Docket No. 50-346

Your letter dated March 8, 1982 (Log No. 918) requested additional information concerning Masonry Wall Design; IE Bulletin 80-11, as it relates to Davis-Besse Nuclear Power Station Unit No. 1. Toledo Edison made a partial response in a May 3, 1982, submittal (Serial No. 814). Additional information and clarifications were provided in a meeting at Bechtel, Gaithersburg on May 27, 1982, between NRC staff reviewers, Bechtel and Toledo Edison personnel.

RESPONSE TO NRC QUESTIONS
MASONRY WALL DESIGN
REVISION 1

FIGURE NO 1

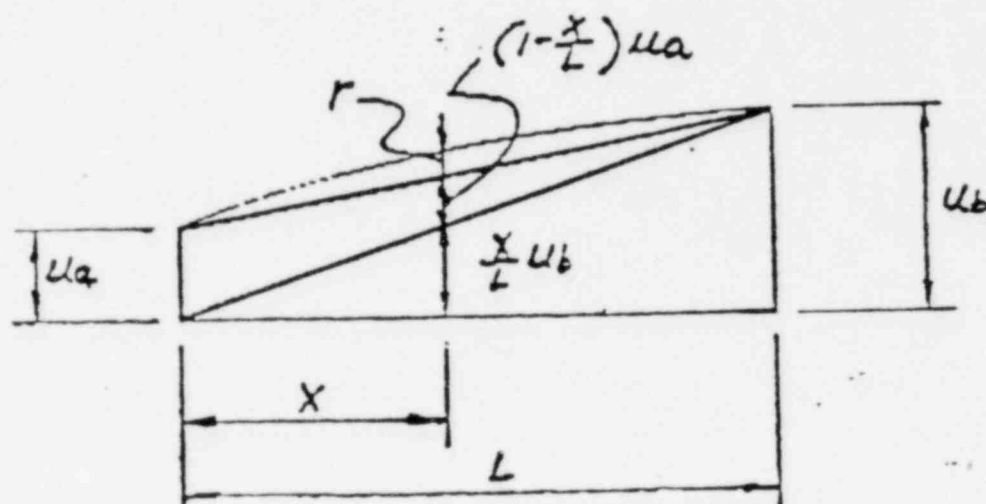
With reference to Section 7.1, Appendix E (2), use the envelope of the floor spectra or provide justification for using the average spectral acceleration.

Response

The evaluations herein demonstrate that the use of the average floor acceleration response spectra to calculate the response of the wall panel is appropriate.

For the purposes of this evaluation, the seismic response of a simply-supported, uniform beam simulating a strip of the wall panel with unit width is considered, as shown in Figure 1:

where L is the length of the beam. The relation expressed by the above equation is shown in Figure 2. The relative displacement $r(x,t)$ must satisfy the following simply-supported conditions:

This illustrates that the use of the average of two floor acceleration response spectra to calculate the modal response of a wall panel is appropriate.
